Preliminary Observations on EPA's Renewable Fuel Standard NPRM

Air Improvement Resource, Inc.
For Renewable Fuels Association

June 10, 2009

CO2eq Emissions, 30 year, 0%

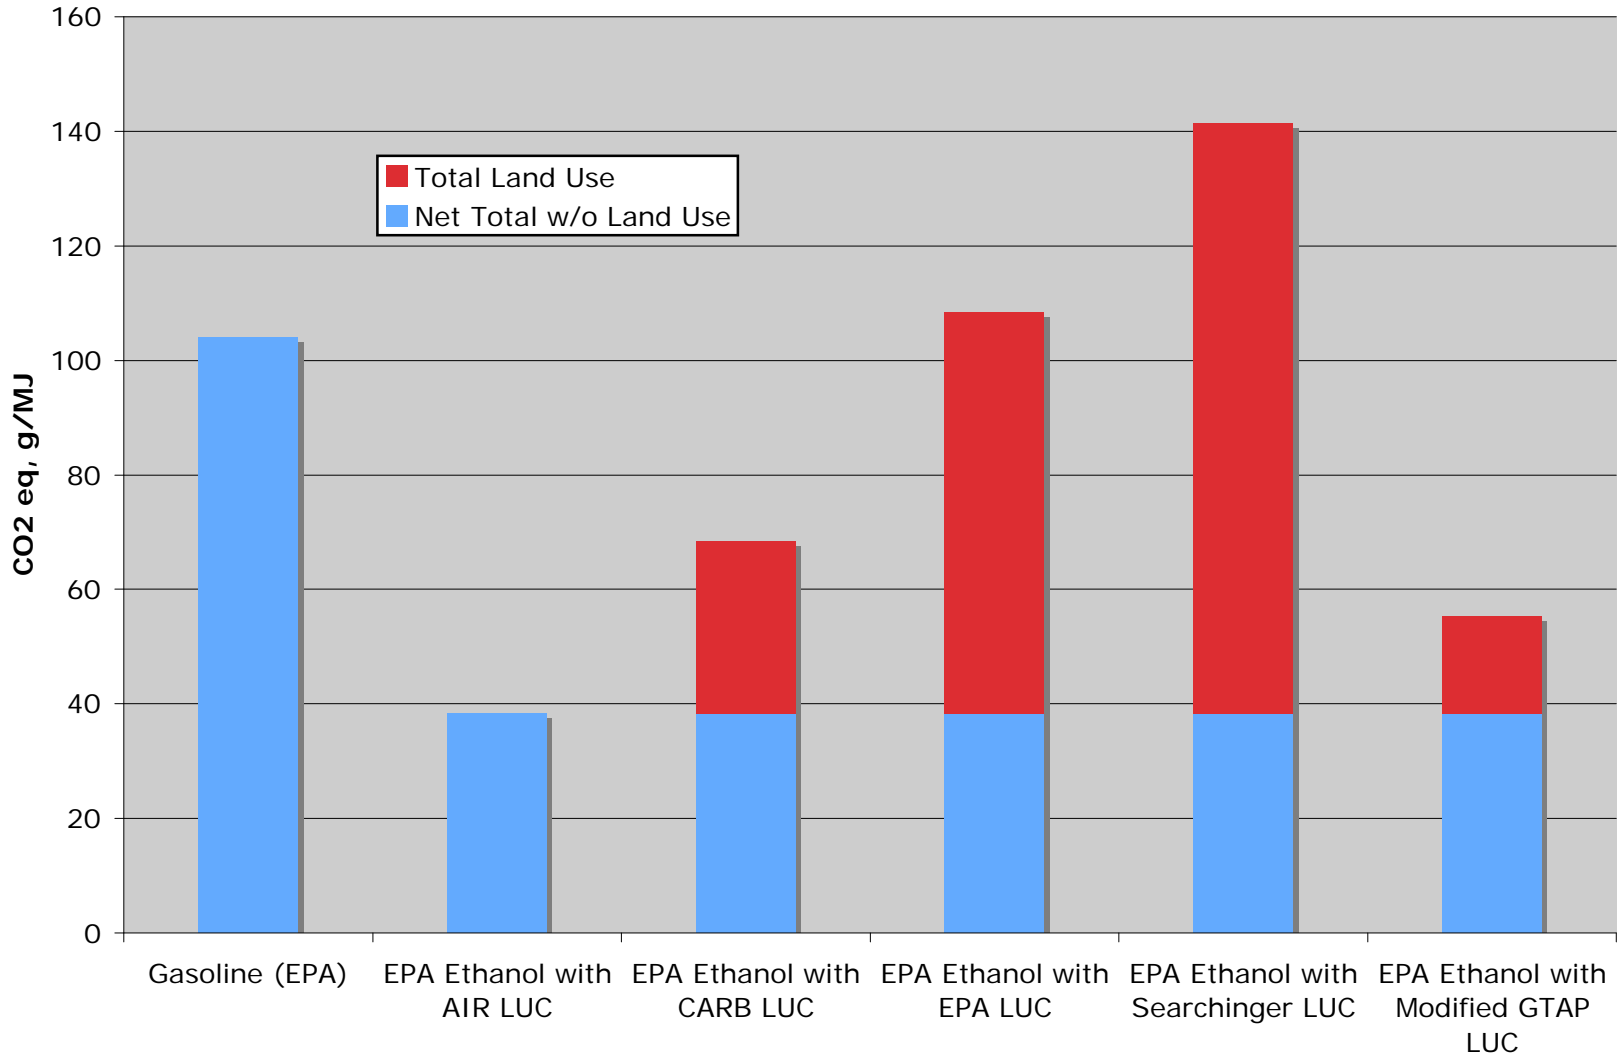
EPA Also Evaluating GTAP

- We support this parallel path analysis
- RIA: “FASOM and FAPRI...do not take into account **changes in productivity** as crop production shifts to marginal acres or the **impact of price-induced yield** changes...We would expect these two factors to work in opposite directions, and therefore serve as offsetting impacts”
- This was also the general conclusion of Dr. Hertel of Purdue in a conference call with ARB, RFA, Purdue, NERA, Informa on April 16, 2009
- When AIR modified GTAP for these 2 factors, we obtained a GTAP LUC value of 17 g/MJ for corn (reduced from 30)

ACTUAL Change in U.S. Exports per Million Gallons of Ethanol

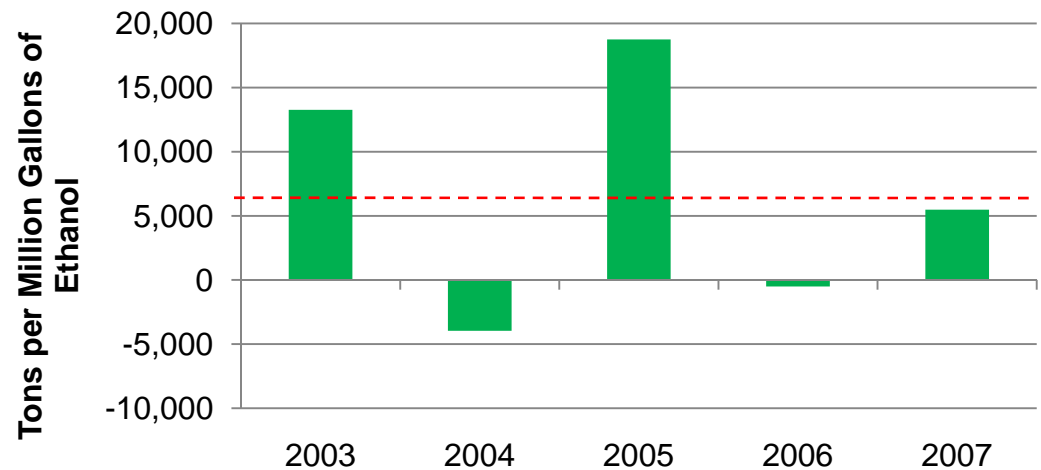
Empirical data shows average of +6,600 tons per million gals. for last 5 years

Highlights need for back-casting
